SUBJECT: AMENDMENTS NOS.129 AND 114 TO FACILITY OPERATING LICENSES NOS.
DPR-58 AND DPR-74: (TACS NOS. 73280 AND 73281)

The Commission has issued the enclosed Amendment No.129 to Facility Operating License No. DPR-58 and Amendment No.114 to Facility Operating License No. DPR-74 for the Donald C. Cook Nuclear Plant, Units Nos. 1 and 2. The amendments consist of changes to the Technical Specifications in response to your application dated January 27, 1989.

These amendments allow a portion of the Waste Gas Holdup System Explosive Monitoring System to be inoperable for 160 days on a one-time basis so that it may be replaced. These amendments also make some editorial changes.

SAFETY EVALUATION BY THE OFFICE OF NUCLEAR REACTOR REGULATION
RELATED TO AMENDMENT NO. 129 TO FACILITY OPERATING LICENSE NO. DPR-58
AND AMENDMENT NO. 114 TO FACILITY OPERATING LICENSE NO. DPR-74

Figure 1. CONCENTRATION OF H₂ AND O₂
REQUIRED FOR COMBUSTION
IN A NITROGEN ENVIRONMENT

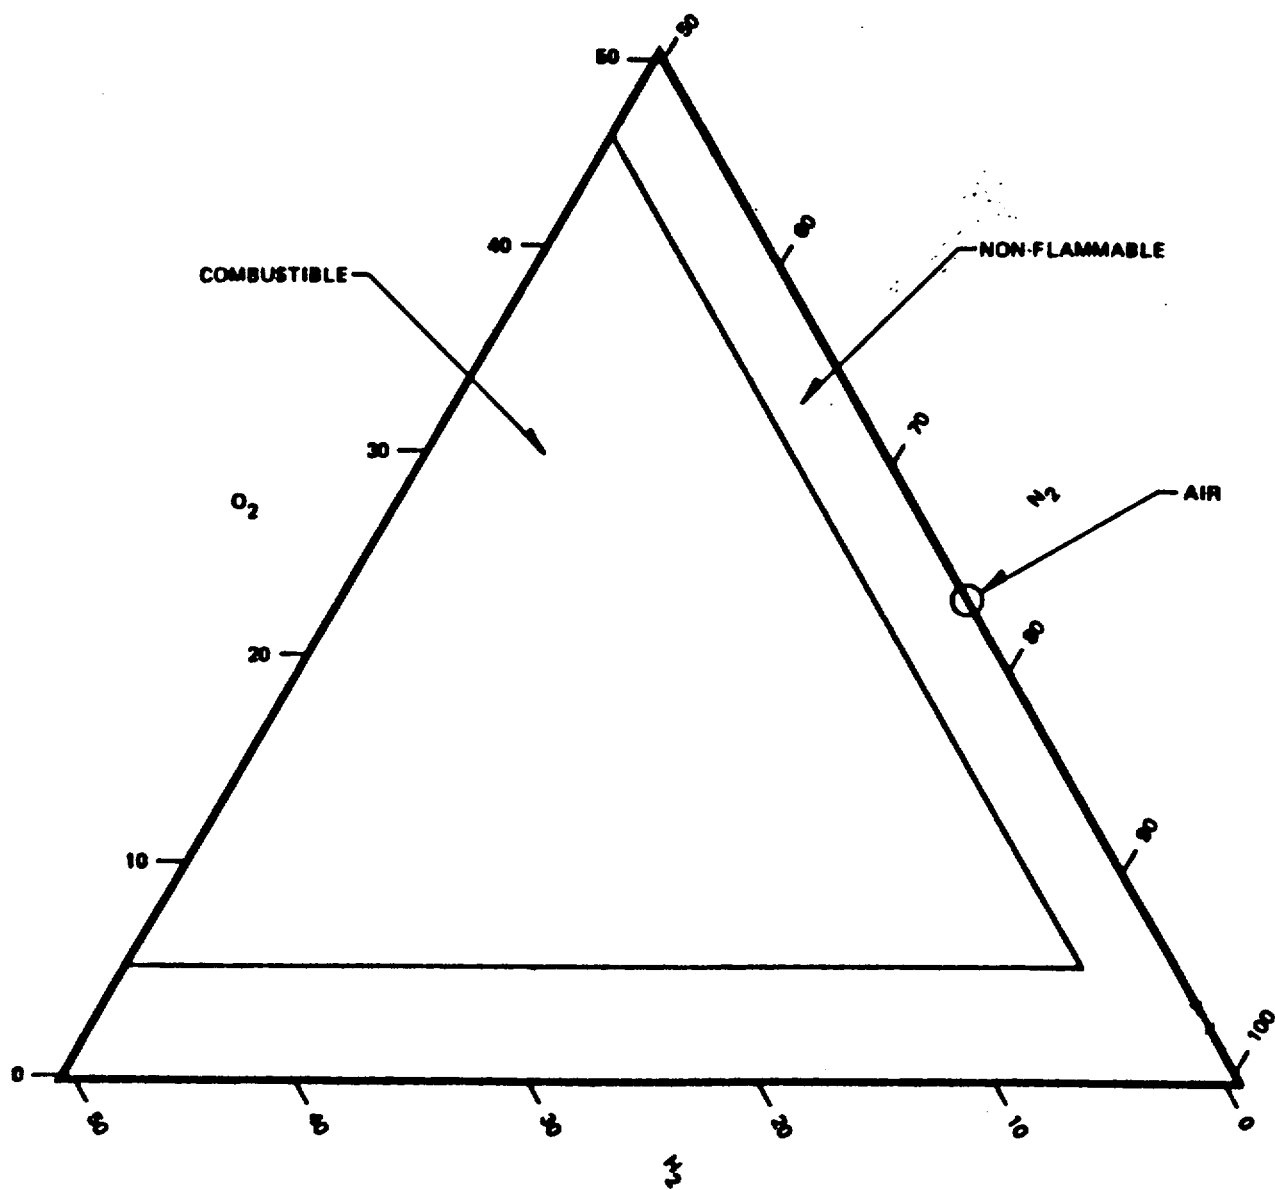
Figure 1 (attached) shows the minimum concentration of oxygen and hydrogen required for combustion in a nitrogen environment which is about 5% and 4%, respectively. (It is assumed that an ignition source will be available.) The licensee has stated that the hydrogen level will be assumed to be higher than the 4% minimum flammable concentration during the hydrogen monitor replacement. Thus, the lack of information provided by the hydrogen analyzer should not increase the probability of combustion during the replacement period. While the unavailability of the QC-31 oxygen monitor during the replacement period does eliminate the redundancy in the capability to continuously monitor oxygen concentration, the prompt automatic actions that may be required in response to oxygen in-leakage into the waste gas system would remain unchanged (i.e., QC-370 would initiate a switching of the waste gas holdup tanks to prevent the oxygen level from reaching the point where it could ignite with the hydrogen). In addition, oxygen concentrations based on grab sample analysis would be available every 12 hours.

The current D. C. Cook TS action statement for the oxygen monitors allows operation of the waste gas holdup system for 30 days with one oxygen monitor inoperable with no compensatory requirement for obtaining grab samples. Grab samples are only required if both oxygen monitors are inoperable. Thus, the licensee's proposal to take grab samples every 12 hours (even when QC-370 is in service) constitutes a level of compensatory action equivalent to the existing TS. If QC-370 were to become unavailable during the replacement period, the licensee would follow the existing TS requirement (i.e., operation of the waste gas system would be discontinued if QC-370 could not be repaired within 30 days).

In a teleconference between the Project Manager and licensee representatives on September 15, 1989, the licensee agreed to increase the sampling frequency to every eight hours during plant shutdown evolutions involving reactor coolant system degassing and during periods of QC-370 unavailability. The licensee also provided rationale for the duration of the requested 160 day replacement period. The licensee fully expects that the modifications will require the O₂ and H₂ monitor system (QC-31) to be out of service for about 80 days. The 160 days was conservatively selected to ensure that unanticipated complications in the installation or testing of the explosive monitoring system would not necessitate an additional TS amendment request.
